From: Scala, Mary Joy
Sent: Wednesday, July 16, 2014 12:13 PM
To: 'Russell Skinner'
Subject: BAR Action July 15, 2014 - 617 Park Street

RE: Certificate of Appropriateness Application
BAR 14-06-02
617 Park Street
Tax parcel 520186000
Chris and Megan Long, Owners/ Russell Skinner, Applicant
New rear addition and site changes

**CITY OF CHARLOTTESVILLE
BOARD OF ARCHITECTURAL REVIEW
STAFF REPORT
July 15, 2014**

BAR 14-06-02

Site Plan
Scale: 1/8"=1'-0"

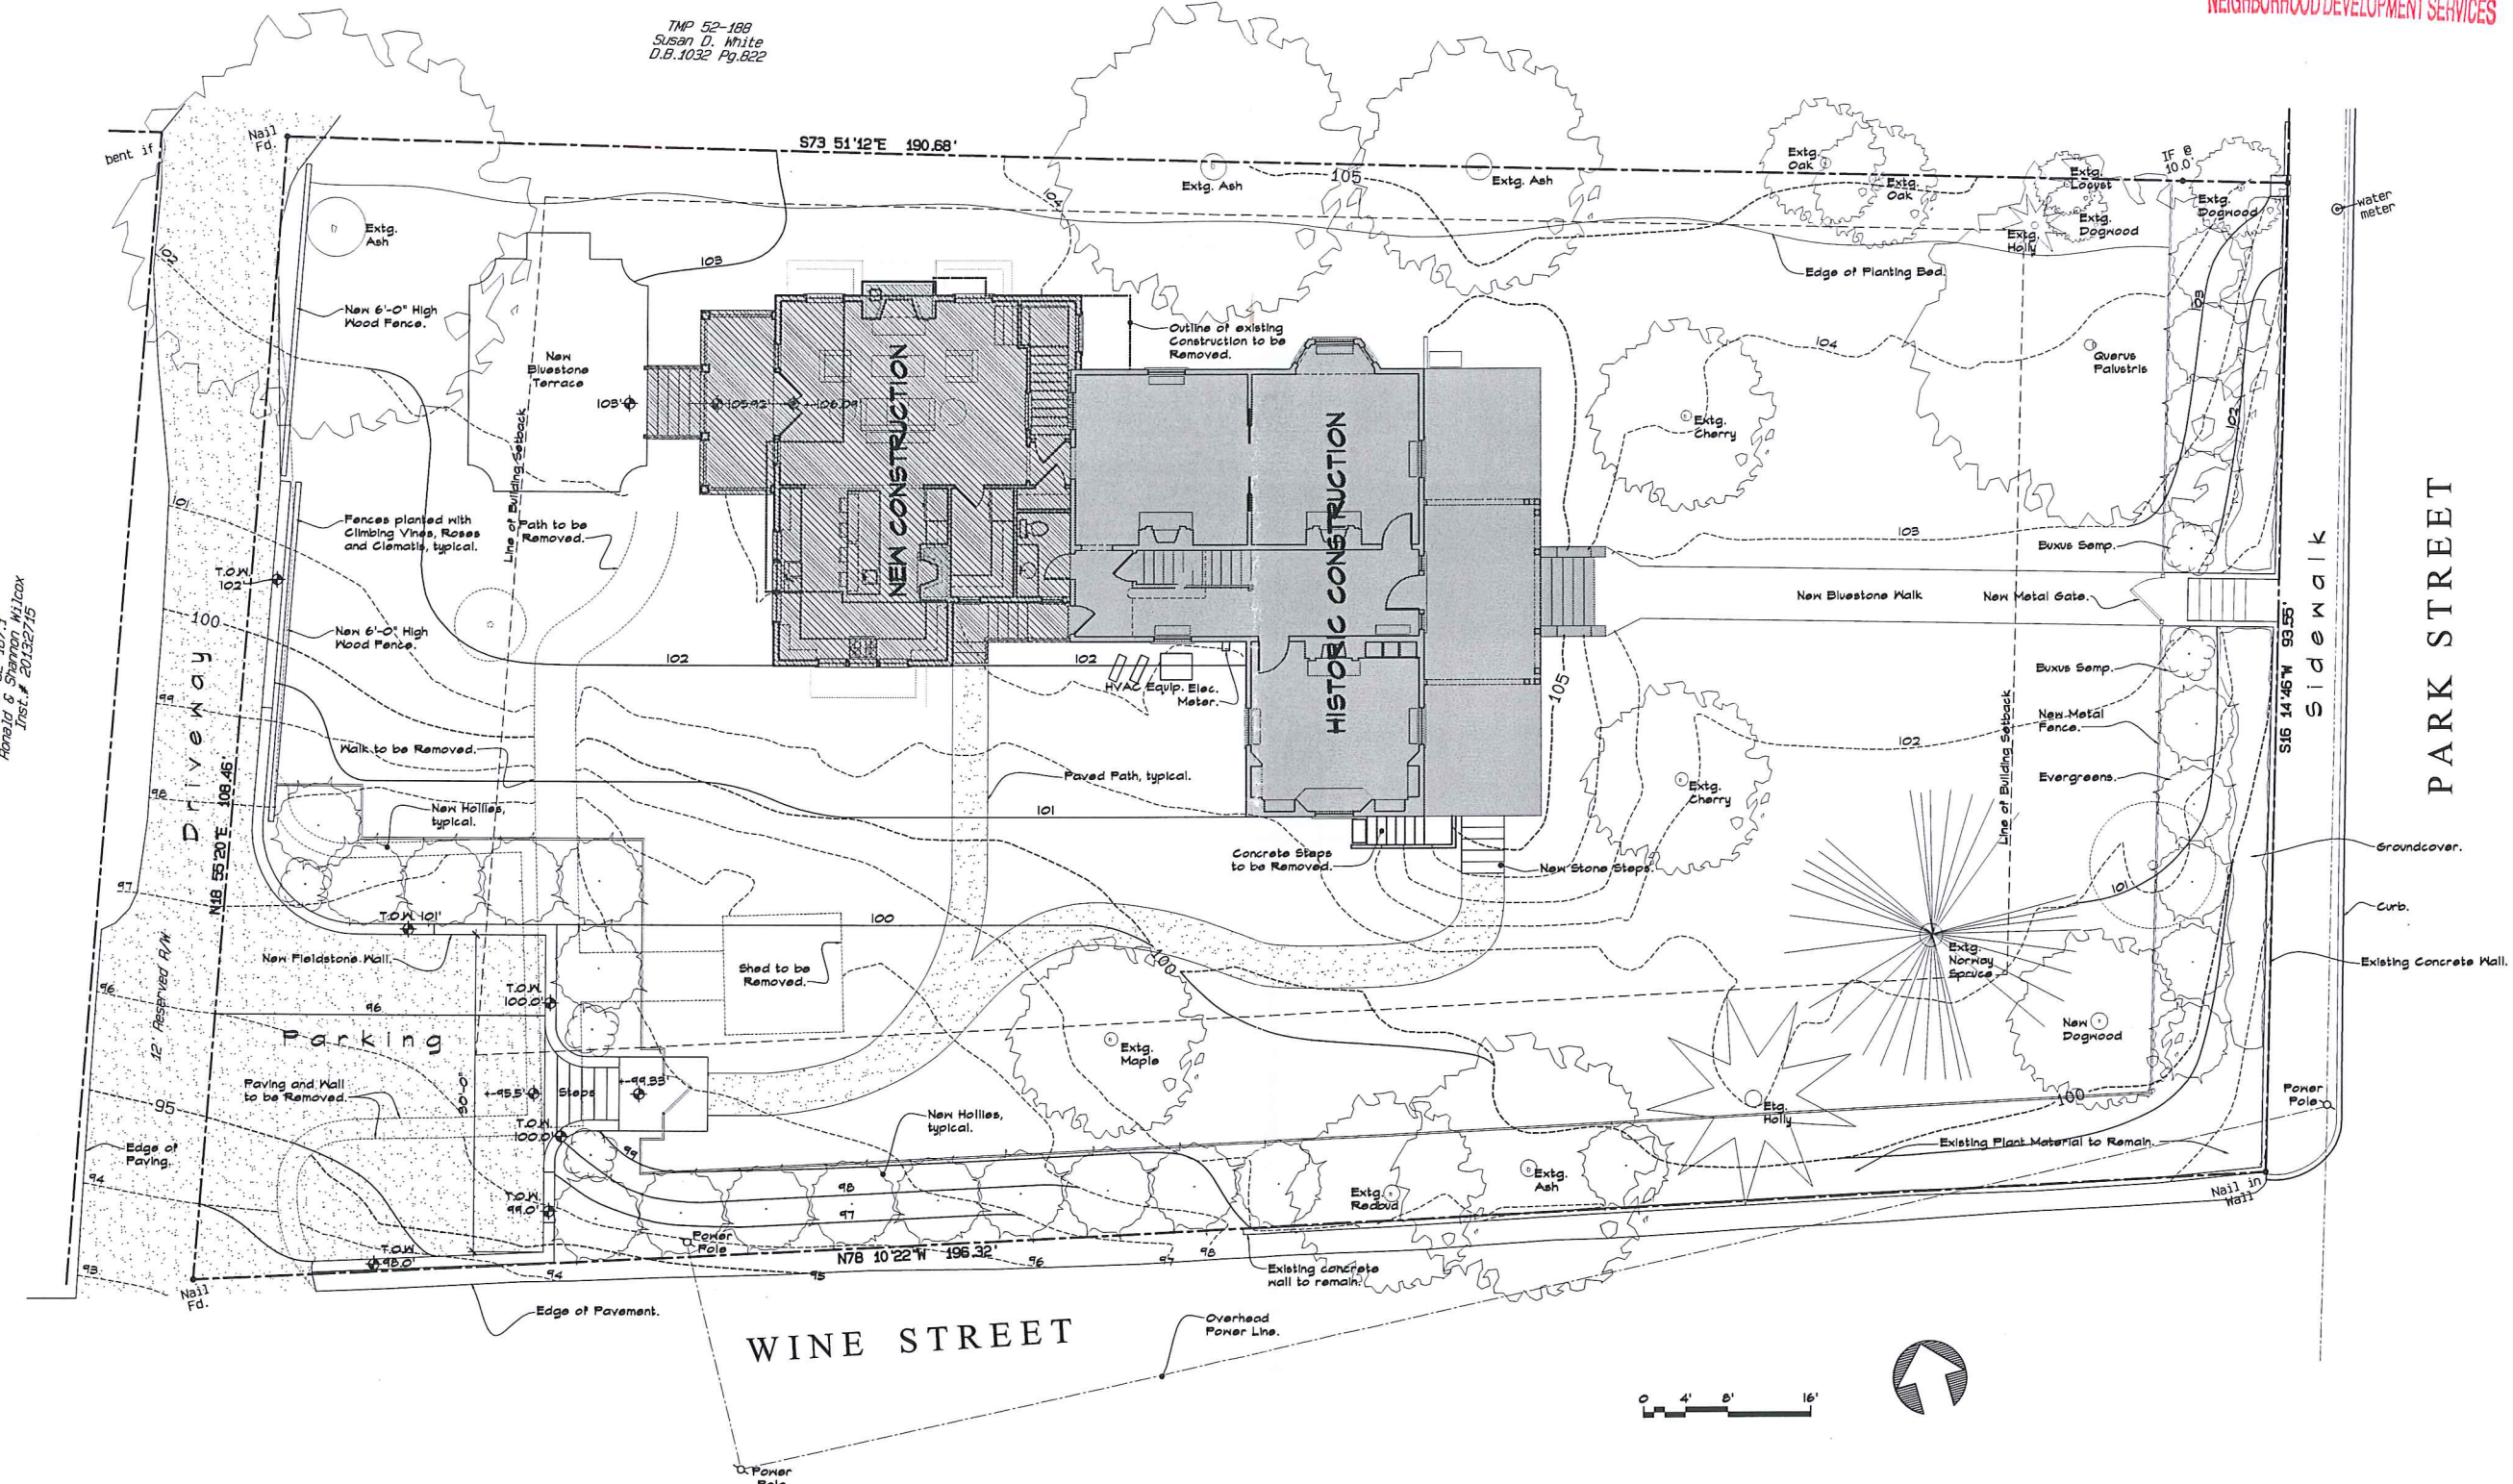
- Expand existing parking area (that backs onto private drive) south to Wine Street;
- New fieldstone retaining wall along private drive ends at parking area; max. 5.0 feet tall;
- Add a Pin Oak tree; keep Maple tree;
- Add a wrought iron gate facing Park Street, rather than a solid wood gate;
- New 6 ft (not 7 ft) high wood fence in rear fence painted Charleston Green;
- Add new stone steps from south side of front porch;
- Reduce the rear porch depth from 10 ft to 7 ft; and eliminate upper porch roof;
- Replace horizontal window on 2nd floor rear elevation with third vertically oriented window.

The applicant has made an argument to retain the tall Holly hedge along Park Street. All other BAR comments appear to be met.

1. Include a street/ canopy tree (Pin Oak)
2. Move the parking to be accessible from the joint alleyway.
3. Incorporate a wrought-iron gate facing Park Street instead of a solid wood gate.

Please refer to the Site Plan.

617 Park St.
2'-0" tall wall
Proposed 6'-0" tall
Evergreen Hedge

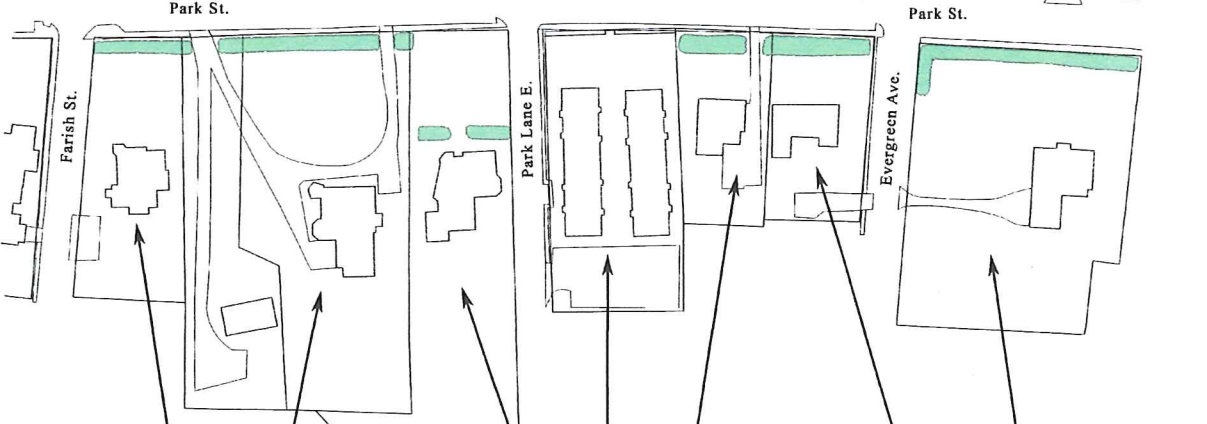
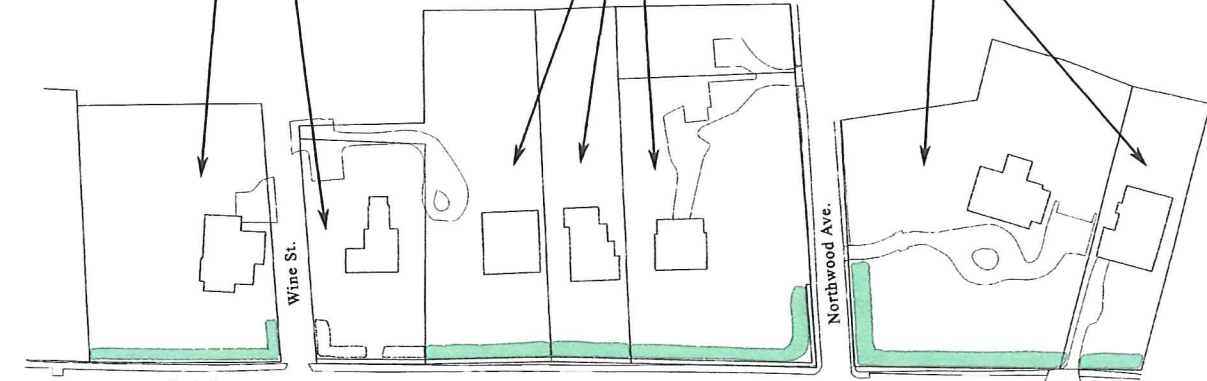
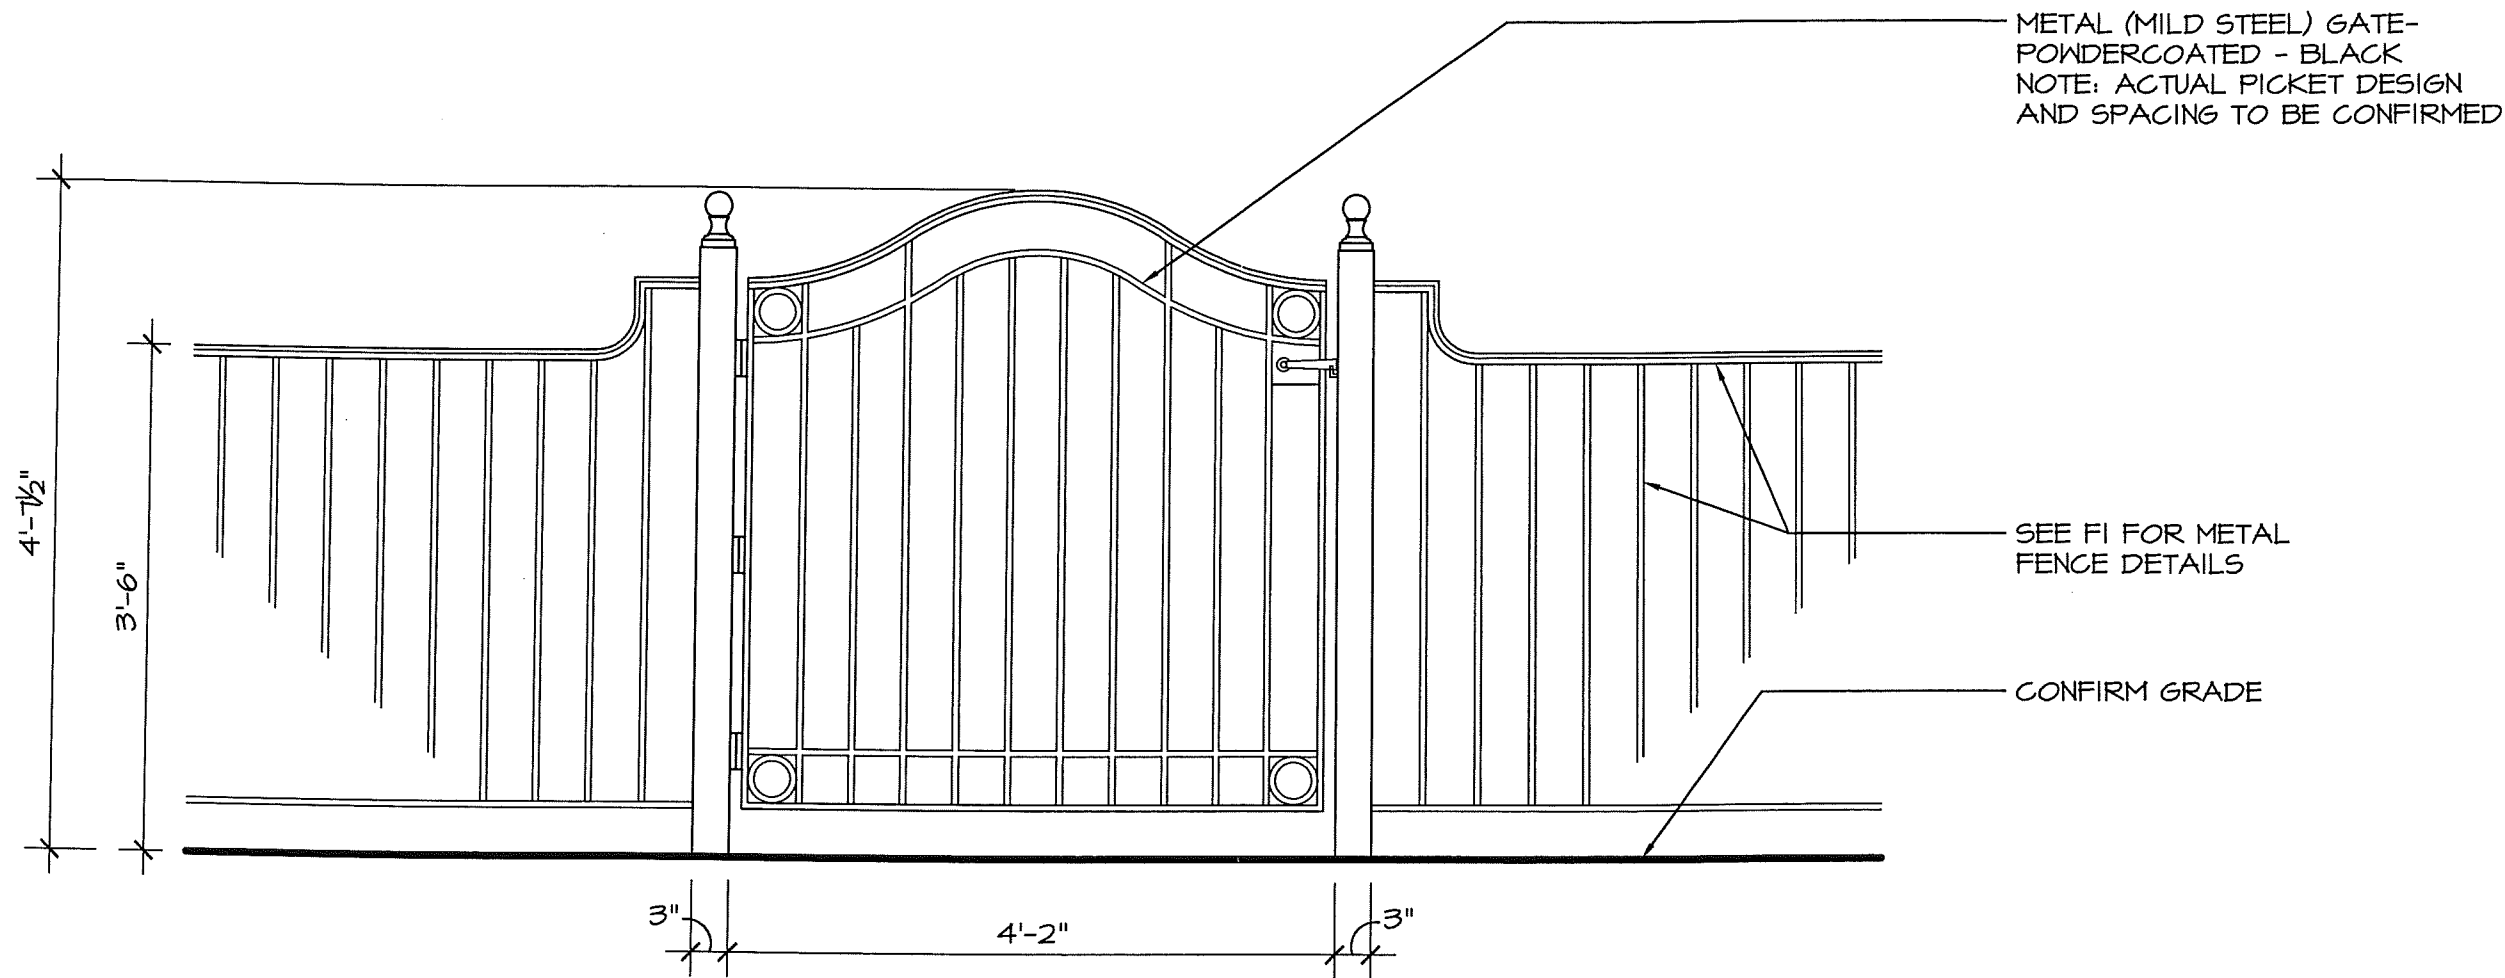
Regarding the proposed hedge along Park Street, our clients would like you to reconsider.

Our clients are a young couple enthusiastically looking forward to living in downtown Charlottesville. When they purchased their new property on Park Street, they maintained a reasonable assumption that they could treat the landscape in their front yard as so many of their neighbors have, that is, with an evergreen hedge. They would very much like to plant a 6 ft. high evergreen hedge in the front of their property facing Park Street.

Our clients wish to use either Boxwood or Holly as hedge material, both of which are clearly consistent with the existing nearby landscape. Nowhere in the guidelines does it suggest a limit on the height of the hedge.

Approved (6-0) proposed addition and site work except hedge on Park Street, for which the applicant has requested deferral to give them opportunity to discuss the revised plan with their clients. If the clients are willing to accept the revised plan [as suggested at the meeting by Ms. Knott] then it can be approved administratively. If not, it should come back for discussion with full BAR.
